# UNITED STATES PATENT AND TRADEMARK OFFICE

APPLICATION NO.	FILING DATE	FIRST NAMED INVENTOR	ATTORNEY DOCKET NO.	CONFIRMATION NO.
10/672,730	09/25/2003	Rod Ross	MO06009C1	9438
<div>7590      01/08/2008</div> <div>MED-LOGICS, Inc. 26061 Merit Circle, Suite 102 Laguna Hills, CA 92653</div>				
			<div>EXAMINER</div> <div>NGUYEN, VI X</div>	
			<div>ART UNIT</div> <div>3734</div>	<div>PAPER NUMBER</div>
			<div>MAIL DATE</div> <div>01/08/2008</div>	<div>DELIVERY MODE</div> <div>PAPER</div>

## Office Action Summary

### DETAILED ACTION

Fig.3

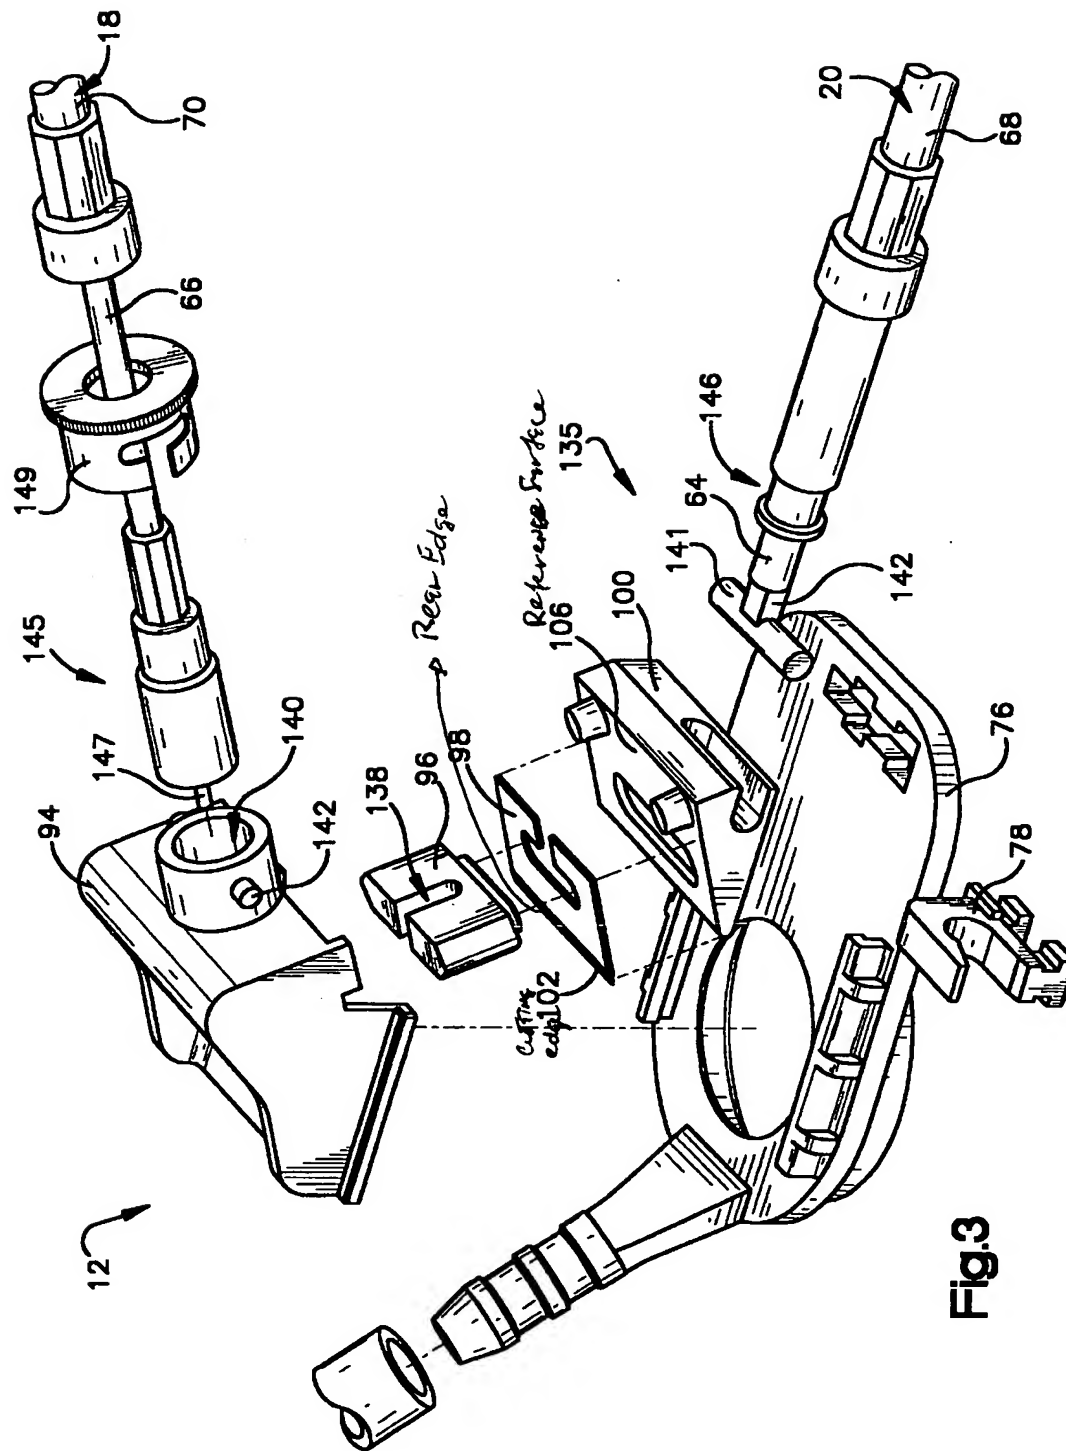
Dybbs discloses a blade assembly that can be assembled into a microkeratome, including: a blade (98) has a cutting edge (102) along a first direction(the first direction occurs along the segment of 102), a rear edge (see attached figure where all yellow mark is characterized as a rear edge, the rear edge has a notch at the opening of blade 98), and a pair of side edges (occurs at either side of element 98), and a second side edge disposed at a distance from the first side edge along a second direction (the second direction occurs along the segment of element 98) where a

blade holder (96) that has a reference surface 106 and an opening 122 configured to receive a pin 135 of the microkeratome, where the blade holder frictionally engaging the rear edge by an amount adjustable along the first direction, where the blade holder reference surface is positioned at an adjustable distance from the cutting edge along the first direction (a functional limitation): thus, a reference needs not show the structure of the recitation in order to meet the claim language but rather the reference needs only be capable of being used with such structure. Accordingly, the reference is considered to read on the claimed limitation of the claimed noted, and where the blade can pivot relative to the blade holder, and where the blade holder also has an outer groove (fig.4), and where the blade holder includes a tapered top surface (see fig.3) and an opening is formed (at 138) in the tapered top surface.
